Technical Booklet

LG Electronics Alabama, Inc.
2023. 11

Refrigerator SVC Bulletins

[Quality_Common] Frost around freezer door. Freezer door does not open & close properly. Replace freezer rails.

2. Current and New (Visual / Part number & Name etc)

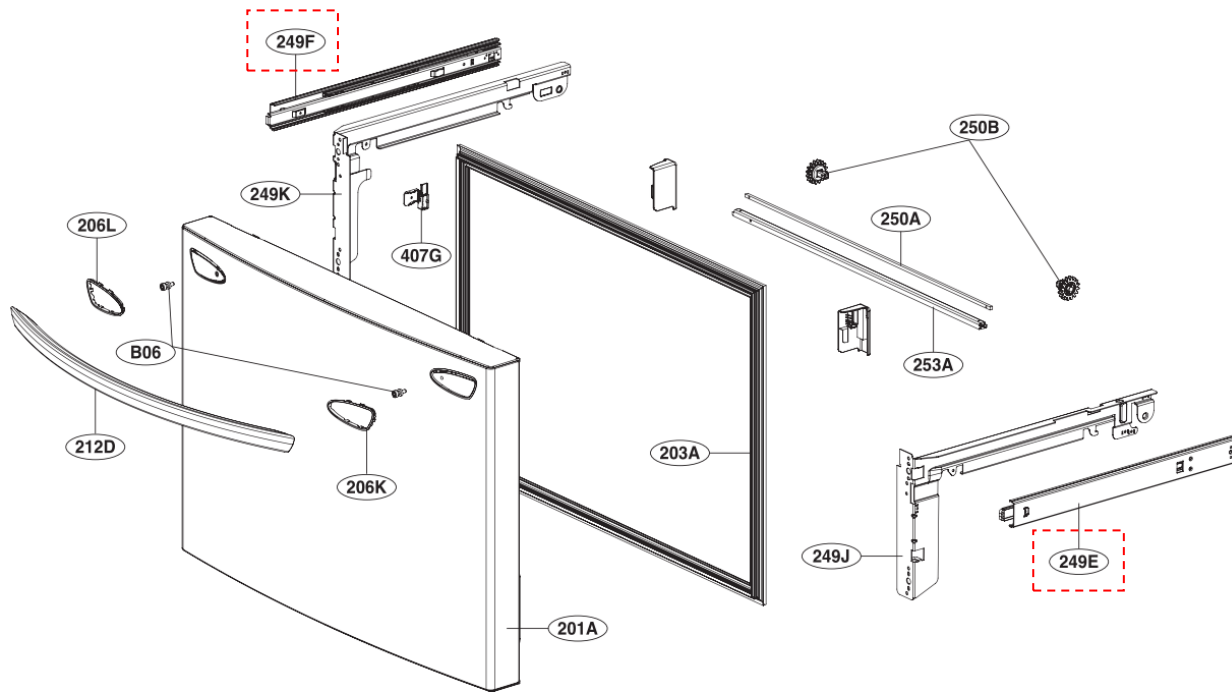
Part Name	Loc No.	P/No.	Remark
Rail,Slide	249F	MGT61844018	Structure improvement
	249E	MGT61844017

P/No. is not changed

[Quality_Common][Key Not Work]Replace Key Not Work Induction Range

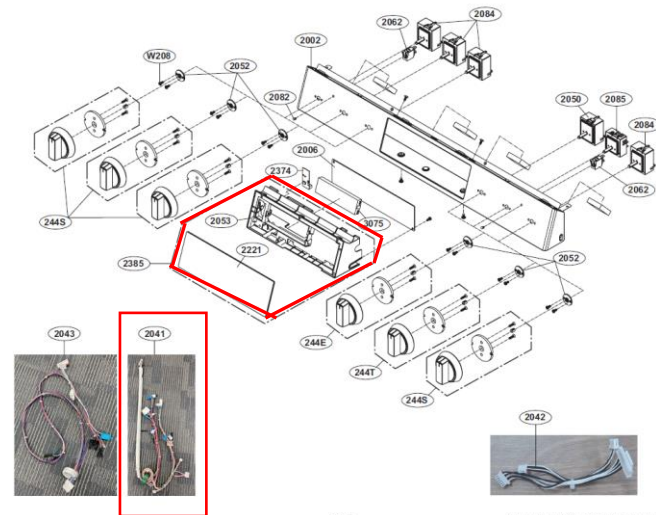
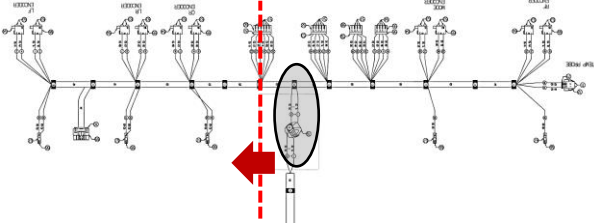
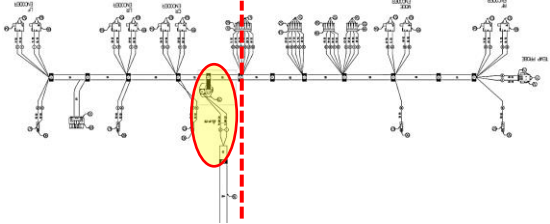
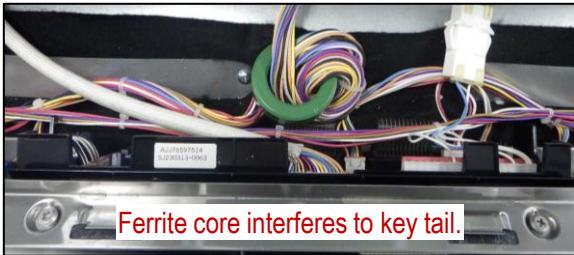
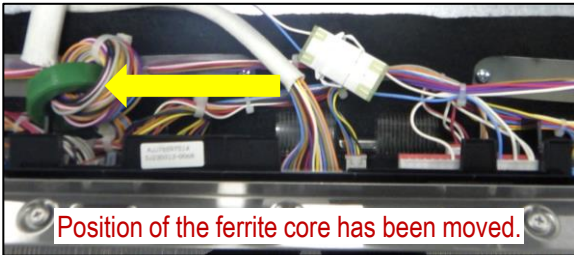
Symptoms	Key/Button not work Controller not responding	Picture	 <p>Ferrite Core</p>	 <p>Key Tail Damaged</p>
Cause	The key tail on the main PCBA is damaged due to the ferrite core interference the key tail.

If the keys/buttons are not work or controller are not responding, replace two parts below.

SVC Location	Description	P/No.
2385	Parts Assembly,SVC	AGM75309047
2041	Harness,Single	EAD63828105

SVC Location	Description	P/No	Visual	
			Before (~308KM)	After (309KM~)
2385	Parts Assembly, SVC	AGM75309047	 <p>It consist of a Supporter,PCB, Membrane(Key Tail), and Window,Glass.</p>	<p>Same (Controller is not changed)</p>
2041	Harness, Single	EAD63828105		<p>The position of the ferrite core in the harness has been moved.</p> 
<p>Assembly Result</p>  <p>※ Note: When connecting the key tail, be sure to fully insert it up to the guideline.</p>
